# Response to Request for Further Information

Planning Proposal PP-2023-2881

193 - 199 Rocky Point Road, 66-68 Ramsgate Road, 2-4 Targo Road,  
Ramsgate

Submitted to Georges River Council  
on behalf of Fabcot Pty Ltd

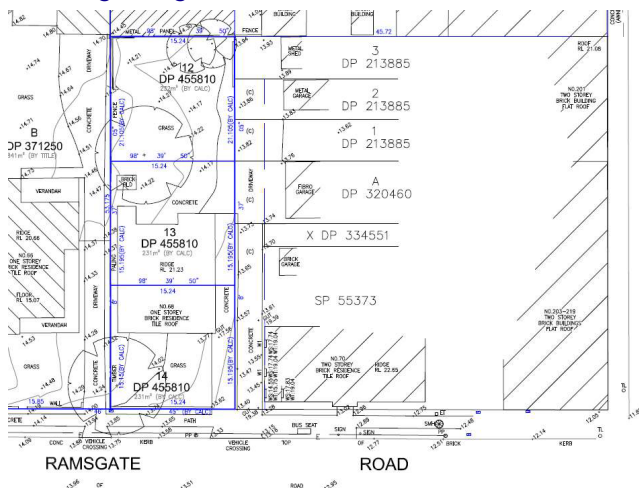
<b>Traffic Impact and Road Network Upgrade</b>	
<i>In order to accommodate future traffic generated from the development, the following road network upgrades are necessary/ warranted:</i>	
<ul style="list-style-type: none"> <li><i>New Traffic signals at Targo Road/Rocky Point Road and Targo Road/Ramsgate Road (as identified in the traffic report and meet the traffic signal warrant)</i></li> </ul>	Noted. New traffic signals at intersections of Targo Road with Rocky Point Road and Ramsgate Road are proposed and will be subject to a future DA.
<ul style="list-style-type: none"> <li><i>Removal of mid-block pedestrian crossing at Rocky Point Road</i></li> </ul>	Noted. The existing pedestrian signals will be removed and subject to a future DA.
<ul style="list-style-type: none"> <li><i>Concrete median island at Ramsgate Road from Rocky Point Road and site frontage</i></li> </ul>	Measures are currently being investigated to limited Ramsgate Road access to left-in and left-out. This will be subject to a future DA.

<ul style="list-style-type: none"> <li><i>The provision of roundabout at Targo Road and Burgess St (to assist with additional traffic volume at this intersection)</i></li> </ul>	The roundabout at Targo Road/ Burgess Street is not required to accommodate development traffic, as the existing priority controlled intersection would operate at a satisfactory level of
<ul style="list-style-type: none"> <li><i>The provision of new traffic signal at Rocky Point Road and Torwood St to allow southbound right turn vehicle access site via Torwood Street, The Promenade and Targo Road.</i></li> </ul>	Traffic modelling indicates there is no nexus between the proposed development and new traffic signals at Rocky Point Road/Torwood Street. Therefore, no signals are proposed or will be proposed as part of the future DA.
<b>Commercial Loading Dock</b>	
<ul style="list-style-type: none"> <li><i>Loading dock off Ramsgate Road (from higher order road) is not ideal and may create potential safety concerns and rear end crashes. All vehicular access including commercial loading dock shall be provided off Targo Road (from lower order road), if possible.</i></li> </ul>	<p>As noted above, the proposed location of the loading dock and access driveway will remain at Ramsgate Road, as this has always been the preferred location. The primary reasons for this being the preferred location are:</p> <ul style="list-style-type: none"> <li>Positioning the access driveway in the proposed location enables access to be provided to the site but also maintains the current arrangement</li> </ul>

<p>for service access to the businesses fronting Rocky Point Road, specifically 201-209 Rocky Point Road. If the commercial loading dock was relocated to Targo Road, as per GYDE's and Council's Traffic and Heritage teams' recommendation, there would be insufficient width provided to facilitate vehicle access to the properties along Rocky Point Road.</p> <ul style="list-style-type: none"><li>• The proposed access arrangement provides an outcome that is consistent with the existing Right of Way.</li><li>• It will ensure a better safety outcome in that vehicles and trucks will be able to enter/exit in a forward direction.</li><li>• It achieves an outcome that will not impact existing properties along Rocky Point Road and not disturb residents on Targo Road.</li></ul>																											
<ul style="list-style-type: none"><li>• <i>If commercial loading dock be approved off Ramsgate Road, design vehicle swept path shall be demonstrated that design vehicle In/Out turning path can achieve using kerbside lane only.</i></li></ul>	Updated swept paths have been prepared by CBRK and are provided at <b>Appendix D</b> , Sheets A1-A2. The updated swept paths shown trucks straddling lane on Ramsgate Road, which is a legal turn.																											
<b>Residential Loading Dock:</b>																												
<ul style="list-style-type: none"><li>• <i>There is no provision for delivery vehicle (removalist vehicle) and emergency vehicle (ambulance) on-site for 144 residential units.</i></li></ul>	A revised indicative reference scheme has been prepared by CHC (refer to <b>Appendix A</b> , Sheet CP12), which provides a space for delivery vehicles and emergency vehicles to service the residential component of the proposal. The location of this space is located at the end of the access driveway which has been created as a result of shifting the location of the residential lift from basement to podium level to sit between the Direct-To-Boot lift and stair to sit further away from the boundary so residential moving trucks can sit alongside Building C when parked as opposed to the boundary																											
<ul style="list-style-type: none"><li>• <i>Separate loading dock shall be provided on-site for residential component for waste collection, delivery and emergency vehicle use.</i></li></ul>	Waste collection for the residential component of the proposal will be via the access driveway from Ramsgate Road. As part of a future DA private collection times can be arranged to ensure there is no clash with the Woolworths loading dock times.																											
<ul style="list-style-type: none"><li>• <i>There will be no consideration of a loading zone on-road.</i></li></ul>	Noted. The proposal does not propose a loading zone on-road.																											
<b>Parking Provision</b>																												
<ul style="list-style-type: none"><li>• <i>The quantum of parking proposed for the development for the residential, supermarket and retail components is assessed by the applicant using parking rates in TfNSW Guidelines which has parking rates lower than those in the GRDCP2021. The TfNSW parking rates used are those for a RFB development in excess of 800m from a railway station.</i></li><li>• <i>A summary of minimum parking requirements using the 2 assessment methods is as follows:</i></li></ul>	<p>The indicative reference scheme has been amended by CHC to provide 3 levels of basement parking with 200 retail parking spaces and 245 residential parking spaces (see <b>Appendix A</b>, Sheets CP09-CP11).</p> <p>Notwithstanding this, the planning proposal does not seek approval for the parking numbers to be developed on the site. The proposed design is a reference scheme only, intended to represent a proof of concept for the future development of the site. Any proposed parking numbers will be the subject of a future development application to be assessed and determined at a future date.</p>

**Table 4 Urban Design Referral**

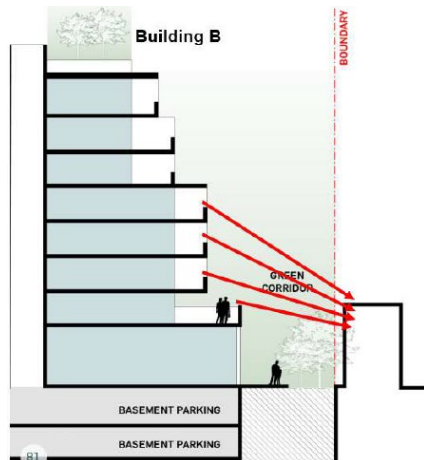
Matter	Response
<b>Principle 1: Context and neighbourhood character</b>	
<p><b>Exclusion of No.6 Targo Road</b></p> <p><i>The subject site is not identical to the previous proposals as No.6 Targo Road has been excluded.</i></p> <p><i>The supporting documentation does not provide any justification for the exclusion of No.6 Targo Road (No.6). Significant concern is raised regarding the exclusion of No.6 from the Planning Proposal and accompanying concept scheme due to site isolation impacts for No.6 and the overall reduction in total site area and lot frontage on Targo Road for the subject proposal. It is understood that the Planning Proposal has not provided any evidence to demonstrate that No.6 cannot be included within the concept scheme.</i></p> <p><i>No.6 is a small site with 480sqm site area and a 9m frontage. Despite its existing R4 zoning, it has restricted development potential due to the presence of an existing multi dwelling housing development to the west at No.8 Targo Road. The Georges River DCP 2021 requires a minimum site area of 1,000sqm for residential flat building (RFB) developments while the Georges River LEP 2021 requires a minimum site area of 800sqm for medium density developments. No.6 does not satisfy either of the minimum site area requirements and therefore is unlikely to be redeveloped beyond its existing low density residential typology.</i></p> <p><i>Accordingly, the subject Planning Proposal must be amended to include No.6 within the subject site.</i></p>	<p>As discussed in <b>Section 2.2.1</b> above, this matter was similarly raised by Gyde Consulting in their review. Whilst landowner's consent is not required for a site to be included in a planning proposal, a planning proposal is based on a reference scheme with an intended future built form that is used to justify the proposed LEP amendments and to inform the preparation of a site-specific DCP. That DCP would then be used as the basis for assessing a future development application for the site.</p> <p>Landowner's consent is required for a development application to be lodged, and it is worth noting that despite the Proponent's best endeavours to acquire No. 6 Targo Road, the landowner has made the decision that they no longer wish to be a part of the proposed development. Given the landowners stated desire not to be part of the proposed development going forward, designing a proposal that factors in No.6 Targo Road is considered unwise at this stage. Reflecting this in a site-specific DCP would have the potential to prejudice the achievement of a future development outcome and for this reason it has not been included.</p> <p>Furthermore, we do not consider that No. 6 Targo Road is at risk of experiencing site isolation in its true sense. It is not a corner site and is capable of future development through amalgamation with adjoining sites to the west. Architectural modelling has been prepared to demonstrate a potential future development scheme which is able to coexist with the proposed development scheme on the subject site to the east (see Drawings CP26 and CP27 in <b>Appendix A</b>).</p>
